- 8. Moose Range Meadows South Addition 1 Jenkins Replat  
KPB File 2024-140  
Edge Survey & Design / Jenkins  
Location: Bayberry Street & Sacaloff Drive  
Funny River Area**

**ITEM #8 - PRELIMINARY PLAT  
MOOSE RANGE MEADOWS SOUTH, ADDITION 1 JENKINS REPLAT**

<b>KPB File No.</b>	2024-140
<b>Plat Committee Meeting:</b>	January 13, 2025
<b>Applicant / Owner:</b>	Charles Jenkins / Soldotna
<b>Surveyor:</b>	Jason Young / Edge Survey and Design, LLC
<b>General Location:</b>	Funny River Rd / Funny River APC

**STAFF REPORT**

**MOOSE RANGE MEADOWS SOUTH, ADDITION 1 JENKINS REPLAT**

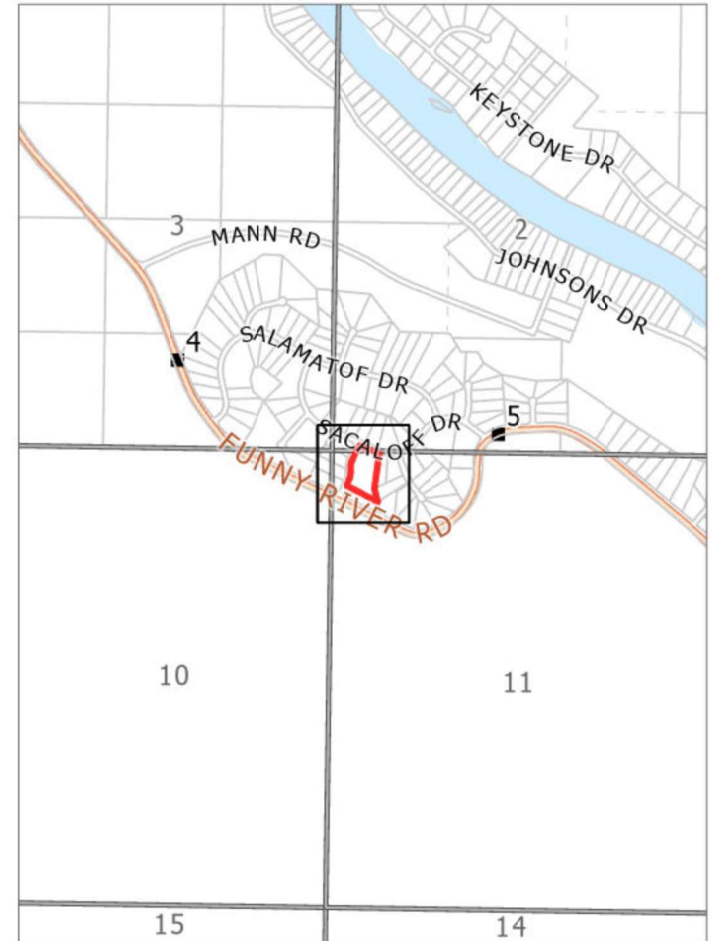
Addressing Review	<p>Reviewer: Leavitt, Rhealyn  Affected Addresses:  NONE</p> <p>Existing Street Names are Correct: No</p> <p>List of Correct Street Names:  SACALOFF DR, BAYBERRY ST, FUNNY RIVER RD</p> <p>Existing Street Name Corrections Needed:  SACRAL DR ON PRELIMINARY PLAT SHOULD BE SACALOFF DR  PLEASE CORRECT</p> <p>All New Street Names are Approved: No</p> <p>List of Approved Street Names:</p> <p>List of Street Names Denied:</p> <p>Comments:  No other comments</p>
Code Compliance	<p>Reviewer: Ogren, Eric  Comments: No comments</p>
LOZMS Review Planner	<p>Reviewer: Raidmae, Ryan  There are not any Local Option Zoning District issues with this proposed plat.</p> <p>Material Site Comments:  There are not any material site issues with this proposed plat</p>
Assessing Review	<p>Reviewer: Windsor, Heather  Comments: No comment</p>

Correct the owners name and city in the address under the certificate of ownership and dedication  
On the fourth line down under the Certificate of Ownership and Dedication, add “by” after and.  
Under the Notary Acknowledgement, correct Charlie to Charles  
Correct the surveyor’s name in the Certificate of Surveyor and the Seal  
Under References, correct Kenya to Kenai.

Correct the KPB File line entirely to KPB File No 2024-140  
Correct the plat name to REPLAT at the end  
Correct the owner's name to Charles as reflected in the certificate to plat and Assessor page.  
Correct the address of the owner to PO Box  
Add to the legal description the parent plat name

Label that Bayberry St is a 60' Right-of-way  
Correct the name of Sacaloff Dr on the drawing.

Lot to the north and on west of Lot 15-A should be labeled Lot 16
